SUBJECT: FINAL DRAFT BRANCH TECHNICAL POSITION ON THE USE OF EXPERT
ELICITATION IN THE HIGH-LEVEL RADIOACTIVE WASTE MANAGEMENT
PROGRAM

**FINAL DRAFT BRANCH TECHNICAL POSITION ON THE USE
OF EXPERT ELICITATION IN THE HIGH-LEVEL RADIOACTIVE
WASTE MANAGEMENT PROGRAM**

Figure 1. Components in an acceptable expert elicitation process. (Numbers next to the process blocks correspond to the technical position statements described in the text. Dashed lines indicate a feed-back loop.)

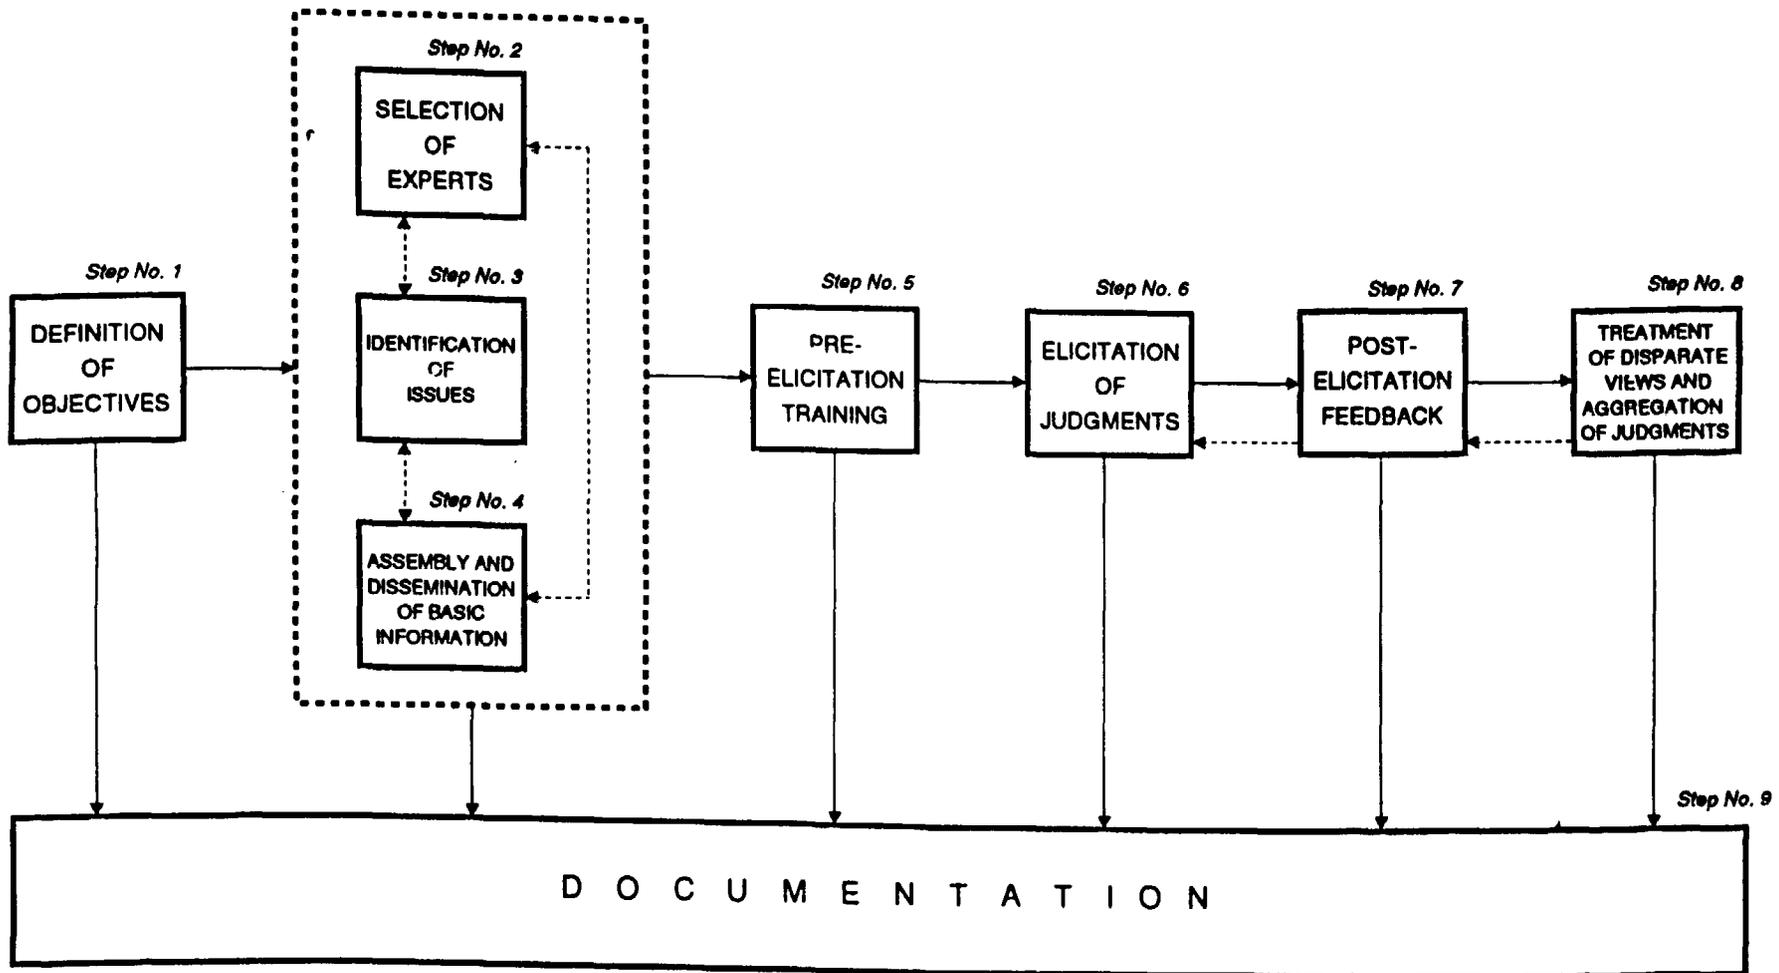
DOE suggestion: Delete the sentence "What this figure shows, into its constituent parts (Step No. 3)" to remove this ambiguity and potential inconsistency that could create a conflict of interest.

The staff does not agree with DOE's characterization of this issue. It is the staff's view that there is no ambiguity regarding the sentence in question (introductory discussion in Section 4 behind Technical Position No. 2 — page 26). The staff is expressing the view in this section of the BTP that subject matter experts, working with the generalist, can help to better define the overall objectives of any particular elicitation. Although not expressed in the BTP itself, it is
